**Maine Maritime Academy
Castine, Maine**

**Pier Upgrades and Waterfront Improvements Project
March 29, 2024
ADDENDUM NO. 7**

PROJ MGR:	RKC	REVIEWED BY:	CHECKED BY:
DESIGNED BY:	MAR	DRAWN BY:	BDW
DATE:	JANUARY 2024	PROJECT NO.:	03.0035109.00
			DRAWING SCALE: S-123 REVISION NO.
			SHEET NO. 52 OF 142

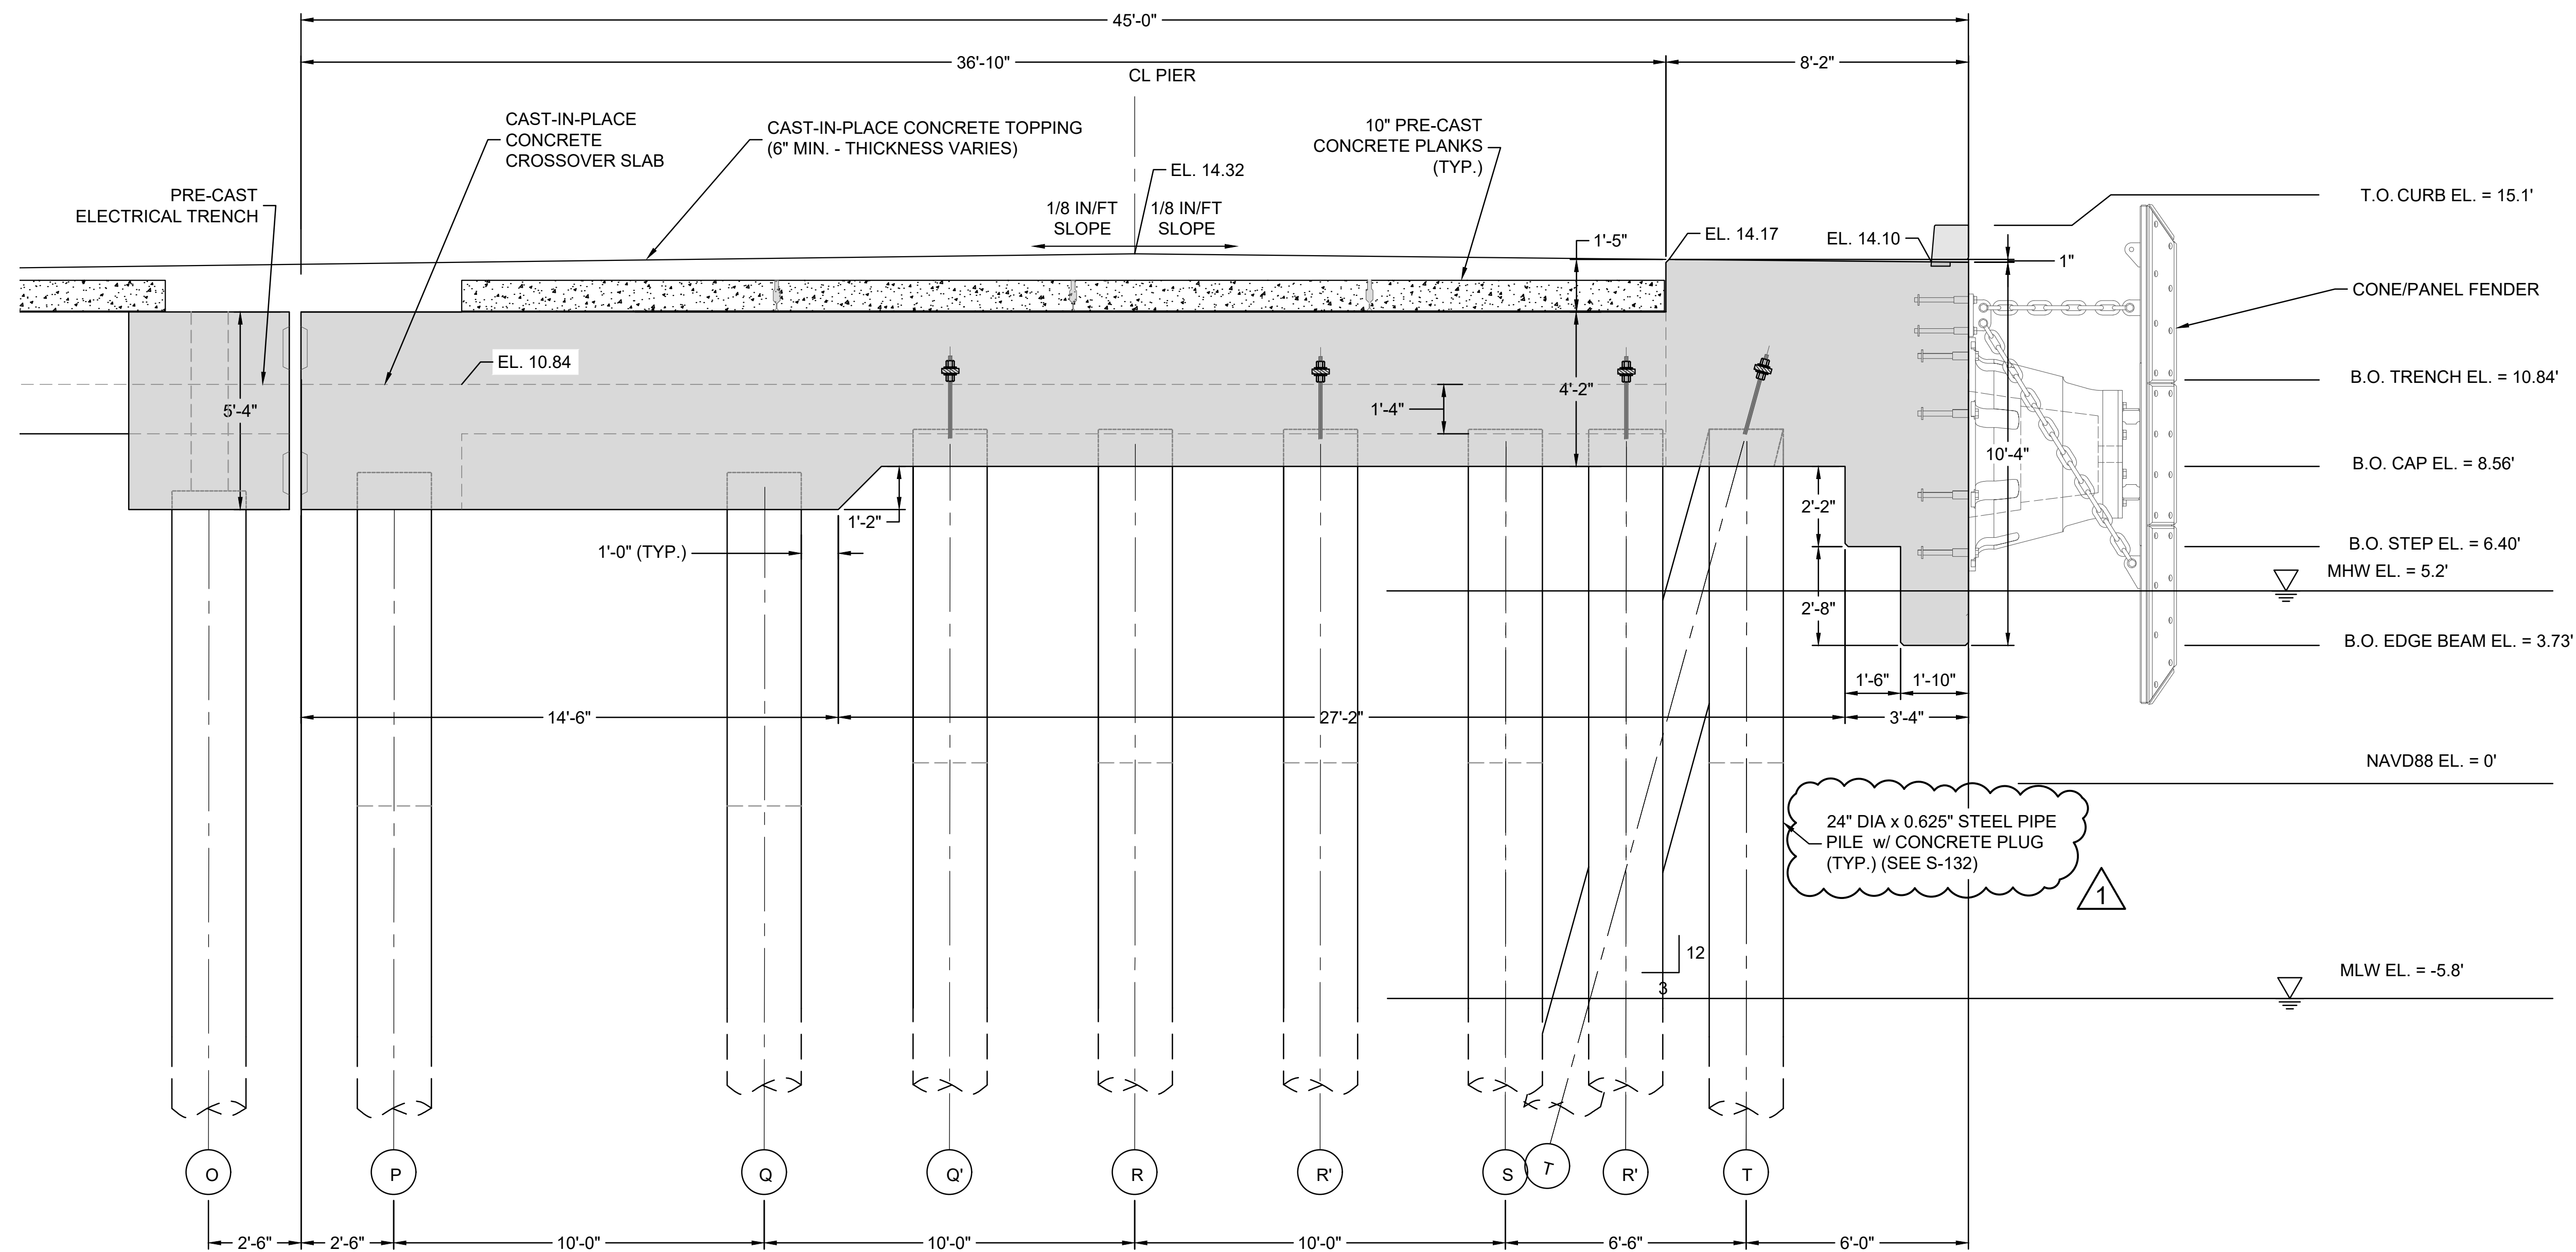
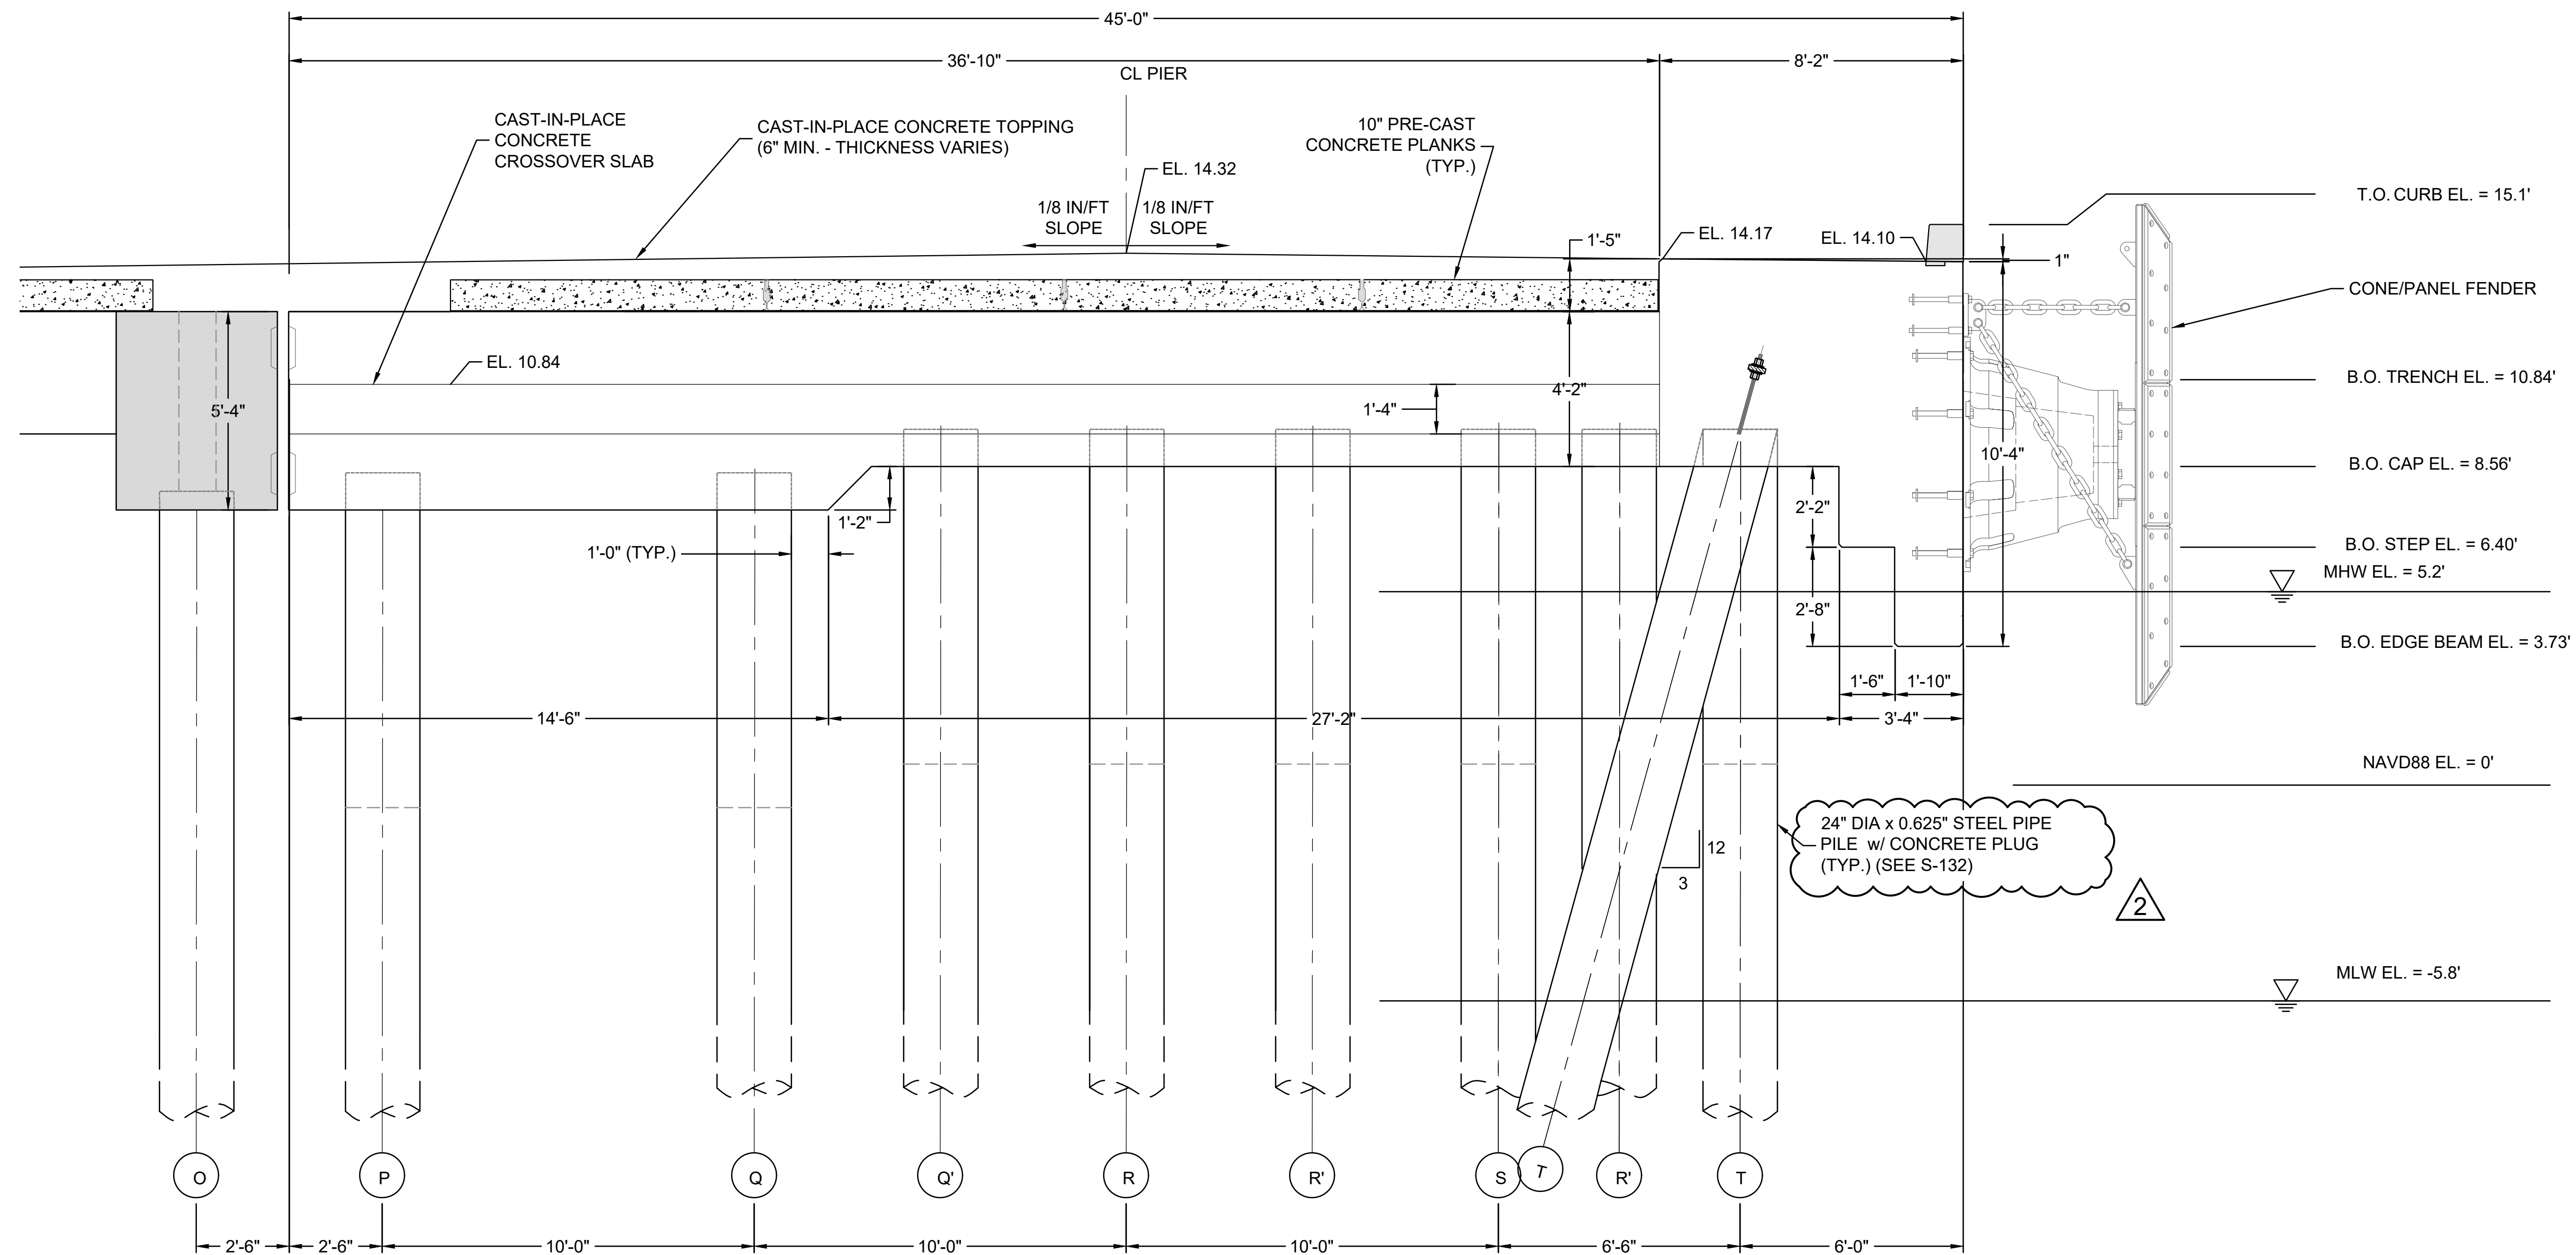
4. Addendum 5, Reissued Drawing S-123: The sheet S-123 issued with addendum #5 shows Rock Anchors in the plumb Pile at Rows Q', R', and what looks to be S'. The pile on the drawing also seem to be mis-labeled with S' missing, two R' 's labeled. Please advise and provide a new Pier Pile and Rock Anchor Table as needed. Please also provide a corrected version of sheet S-123.

Response 4: Piles in Rows Q', R', and S' are battered along the longitudinal length of the pier (i.e. into the page on S-123). See Sheet S-114 for the batter orientation. On IFB Drawing S-123, **REVISE** the R' pile designation between the S and T designations to S'.

PROJ MGR: RKC	DESIGNED BY: AFS	REVIEWED BY: CWC	CHECKED BY: DDF
DATE: JANUARY 2024	PROJECT NO. 35109.00	DRAWN BY: MEA	SCALE: AS NOTED
		REVISION NO.	
			FIGURE S-176

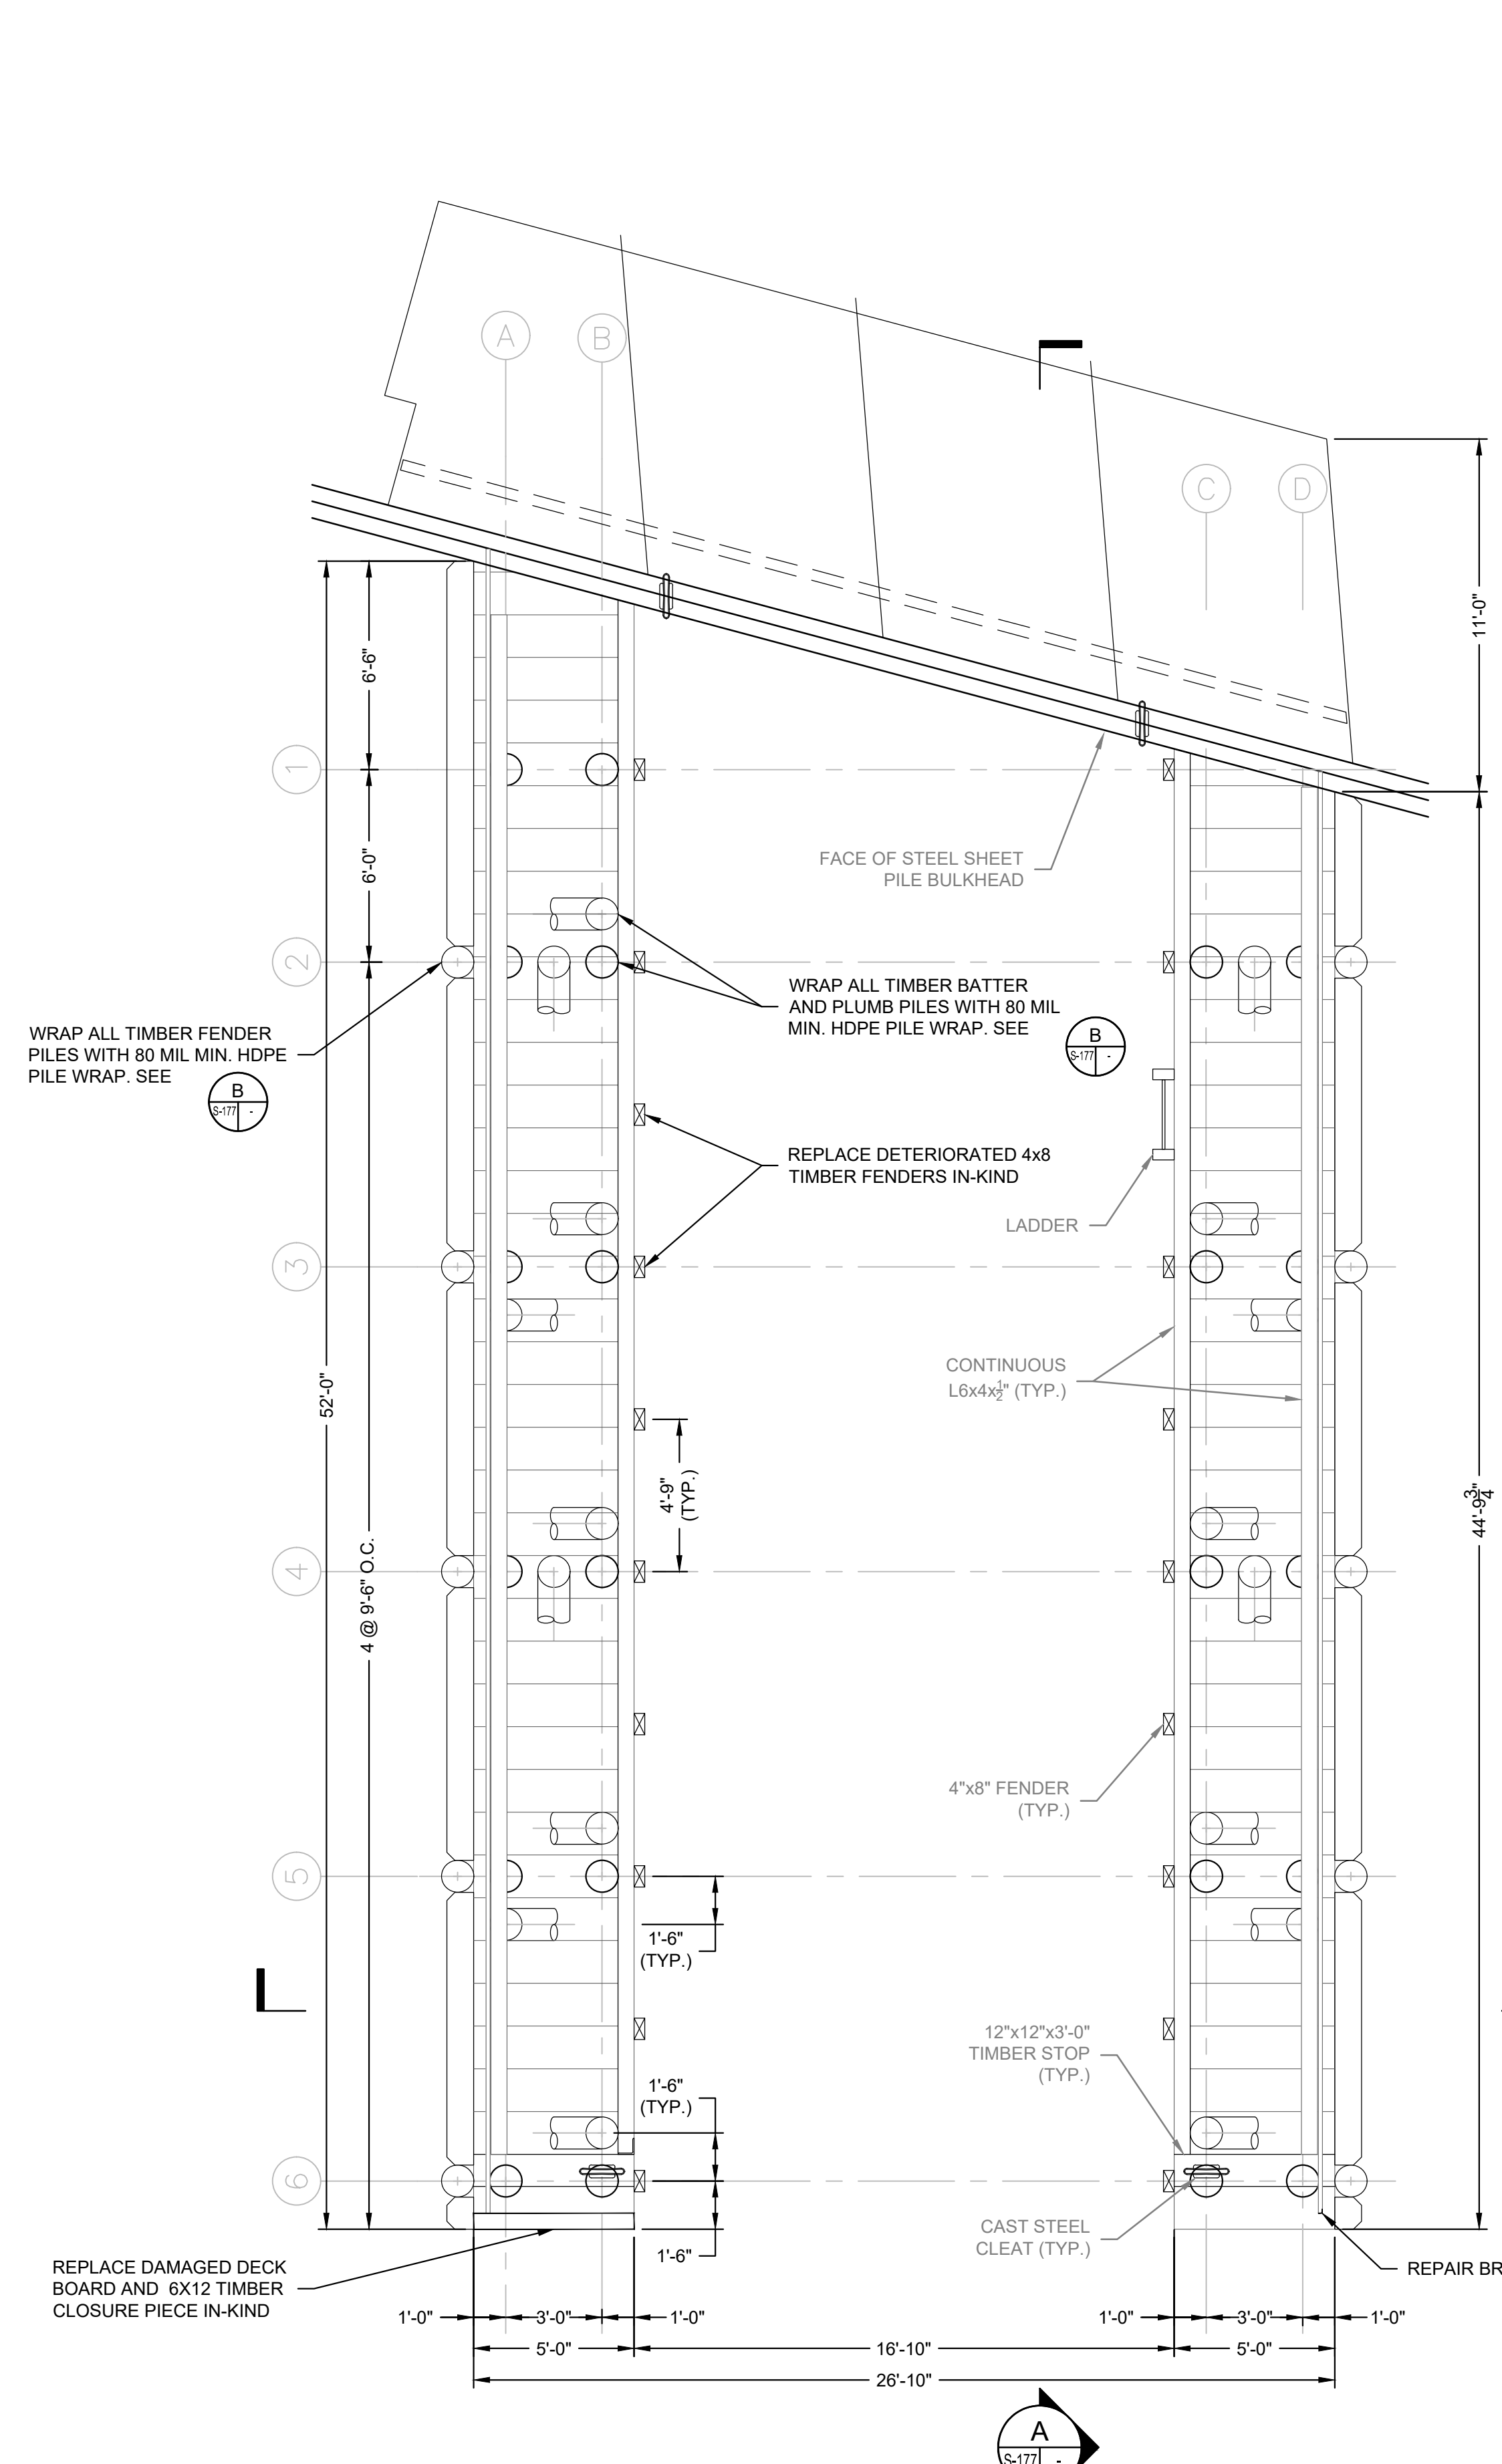
28. IFB Drawing S-176: Floating Breakwater Pile Sockets on sheet S-176 requires a grout filled annular space. No other pile sockets have this requirement. The typical bullet proof method to achieve this would be an oversized temporary casing seating in bedrock so the 32" socket can be drilled and tremie grouted before the pile is placed in the socket.

Response 28: Grout filled annular space will not be required if the floating breakwater guide pile rock sockets are installed within the tolerances of Section 31 62 23.13 Paragraph 3.8.1. In IFB Drawing S-176, Detail 3/S-151, DELETE the diameter of the rock socket and grout filled annular space from the callout.
